1x6 Vee groove pine paneling to match existing at ceiling over 1 hour rated metal stud wall w/ 5/8" GWB each side. See details. Aluminum storefront framed perimeter w/ sealed, butt glazed vertical joints -Sprinkler water curtain on both sides of between glass panels. Glazing glass. Sidewall sprinkler heads spaced to to be 1/2" thicknessbe centered on each glass panel. See tempered. attached product literature for additional installation requirements. Equal **EQUAL EQUAL** EQUAL 7'-4" Confirm R.O. in field. Intent is to make the largest opening Confirm R.O. in field. Intent is to make the largest opening possible while clearing the diagonal struts at the concrete possible while clearing the diagonal struts at the concrete column and allowing enough space at the inside corner for column and allowing enough space at the inside corner for specified post and 4" expansion joint 1 hour rated metal stud wall w/ specified post. 5/8" GWB each side. See details. ELEVATIONS OF UPPER CAFE WALLS THAT SEPARATES CAFE FROM POWERPAY OFFICE SPACE AND EXERCISE ROOM

Winton Scott Architects

ASK

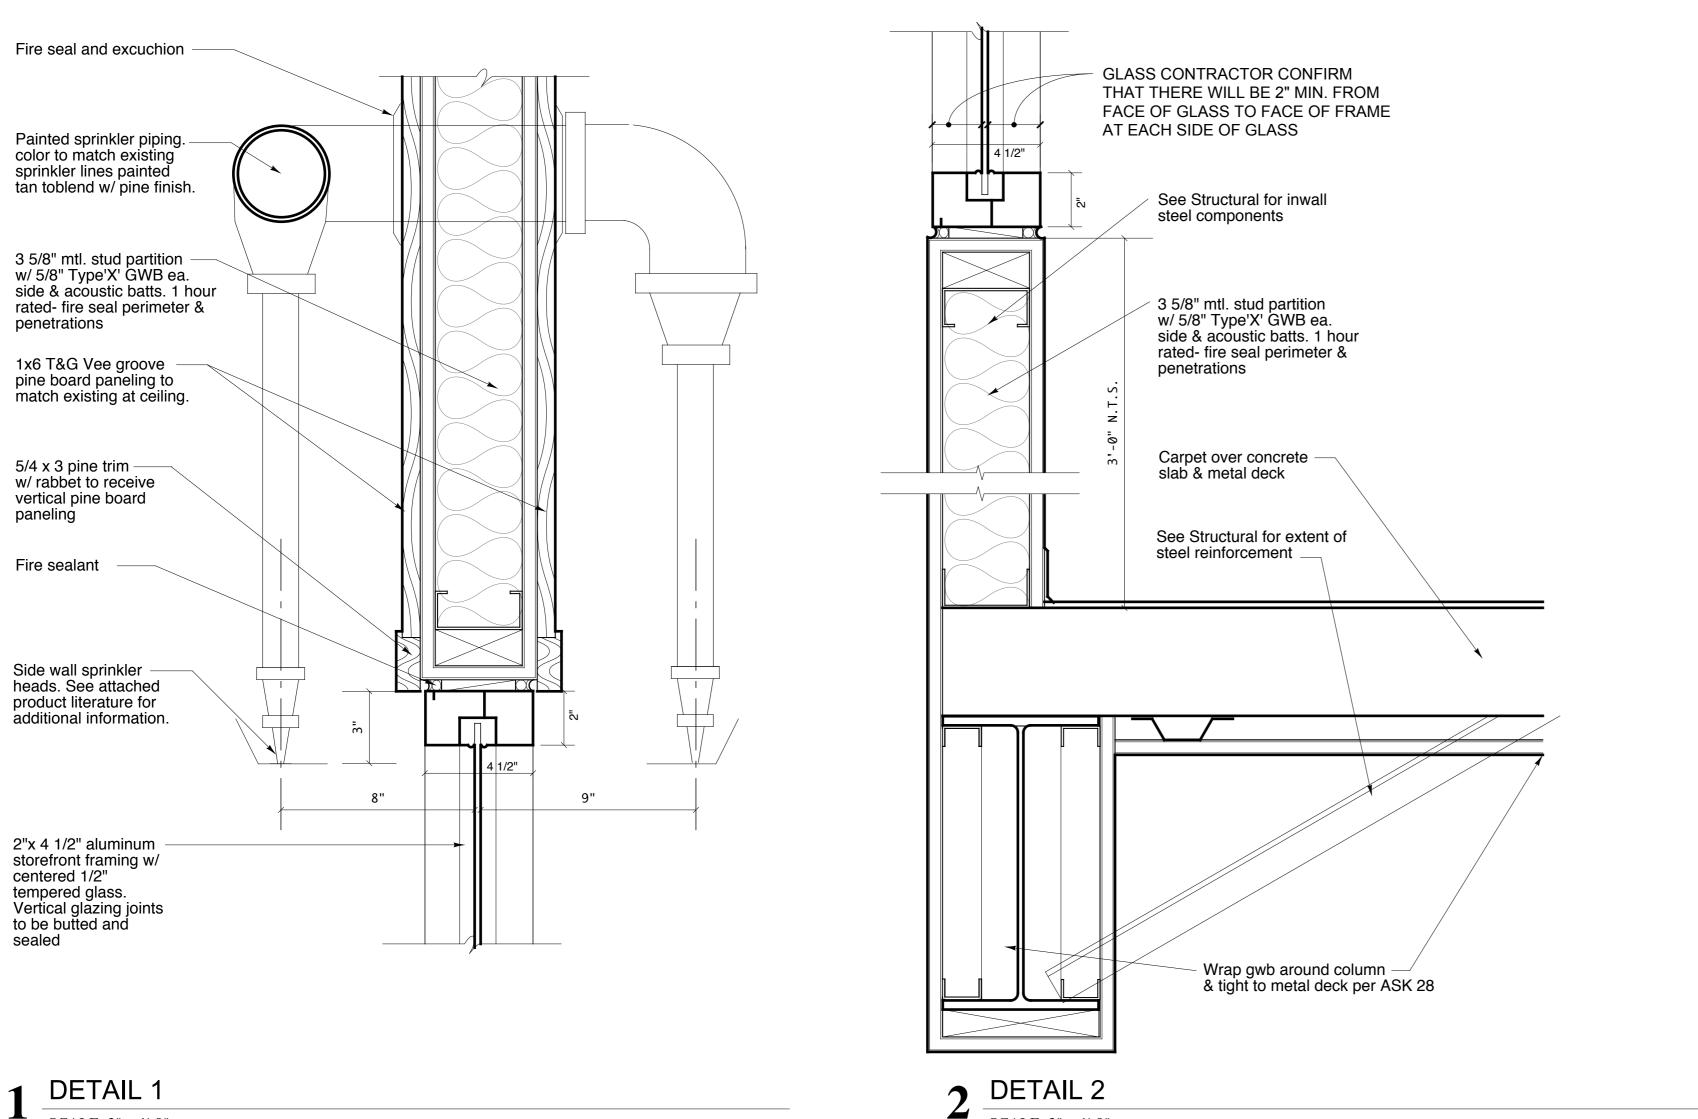
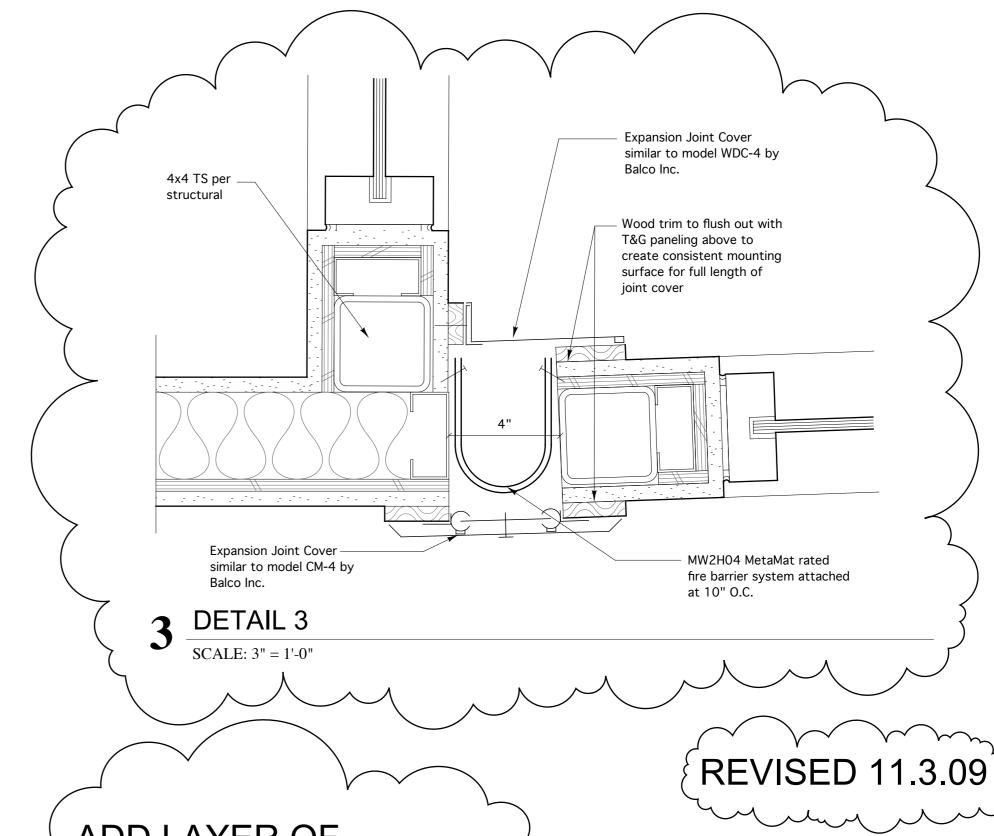
ADD LAYER OF 1/2" PLYWOOD AT **BOTH SIDES OF** PARTITIONS UNDER **GWB LAYER - TYPICAL** OVER ENTIRE PARTITION SURFACES. (NOT SHOWN ON DETAILS)
